City of Deltona

DEVELOPMENT REVIEW COMMITTEE MEETING

DRC Staff Report

The applicant proposes revisions to the landscape plan associated with the approved Racetrac Site Plan Application - File #FSP 12-002.

Irrigation Plan
RACETRAC #1040 - Deltona
 Howland Blvd. & Forest Edge
 Deltona, FL

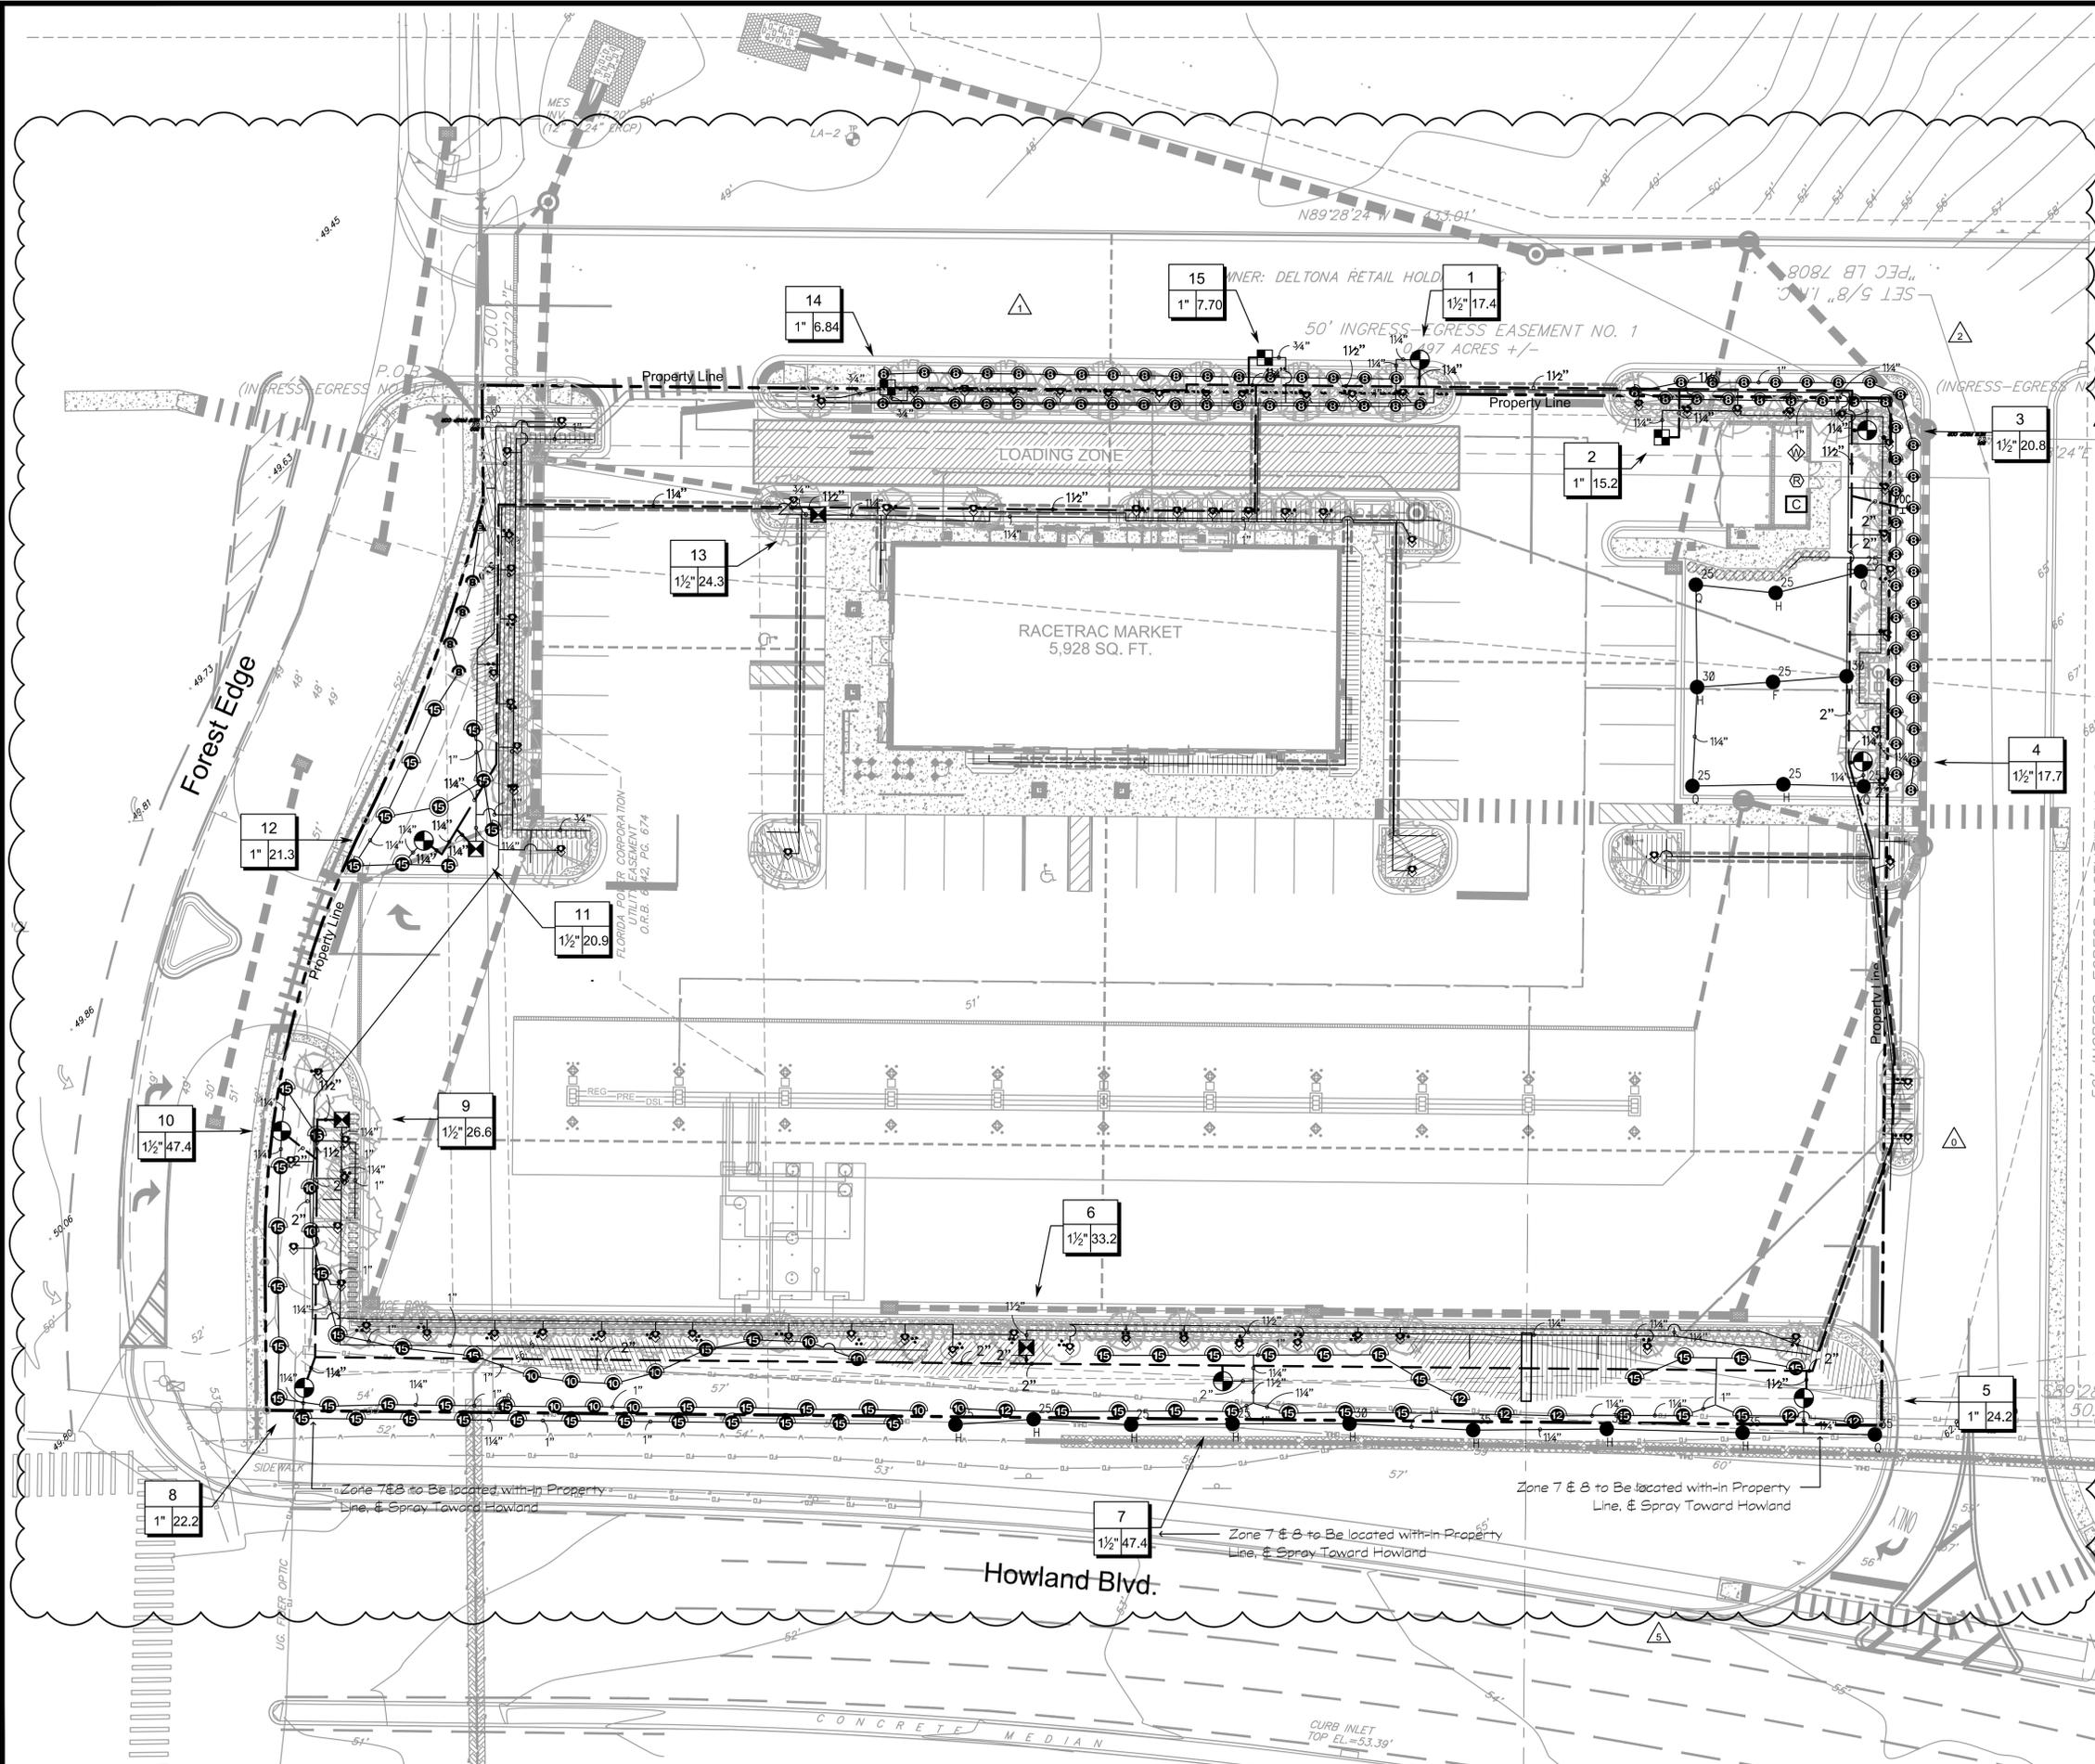
All irrigation lines shall be installed on site and not within any adjacent rights of way.

Notes: Zones in ROW Deleted, Note added to Zones 7 & 8
 Update Tree Bubblers
 Update Zones and EQ per planting
 Removed Meter, Located Well
 Updated tree locations
 Update front irrigation
 REVISIONS
 NO. DATE BY
